Service Bulletin

Reference #054

Dungs Valve Proving System Verification

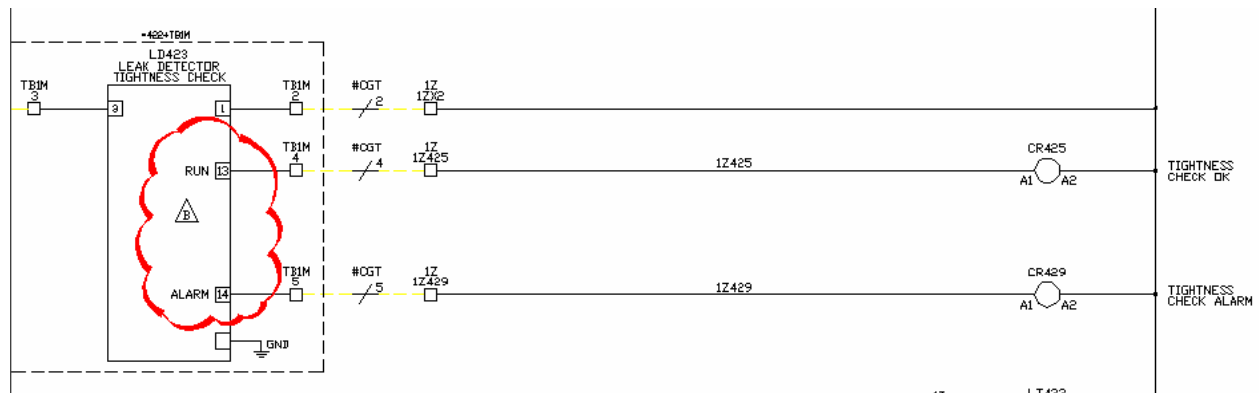
TIGHTNESS CHECK OK Output – Wire number 1Z425 should be terminated on **Terminal 13** of the Dungs Valve Proving System.

TIGHTNESS CHECK ALARM Output – Wire number 1Z429 should be terminated on **Terminal 14** of the Dungs Valve Proving System.

Valve Proving System Terminations:

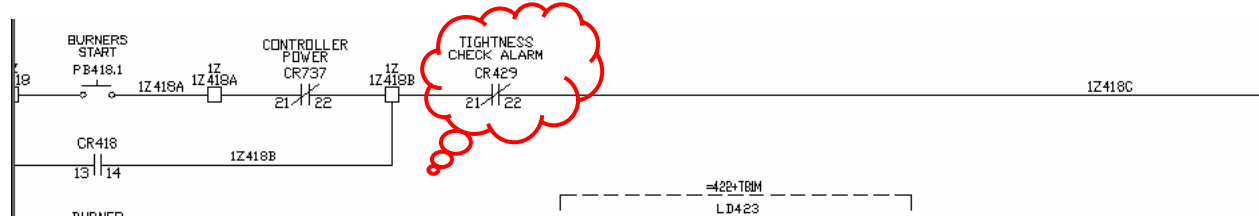
The following indicates the affected wiring found on Glasstech drawing number XXX-460-W001-D sheet 4 of 40. (where xxx represents the furnace number)
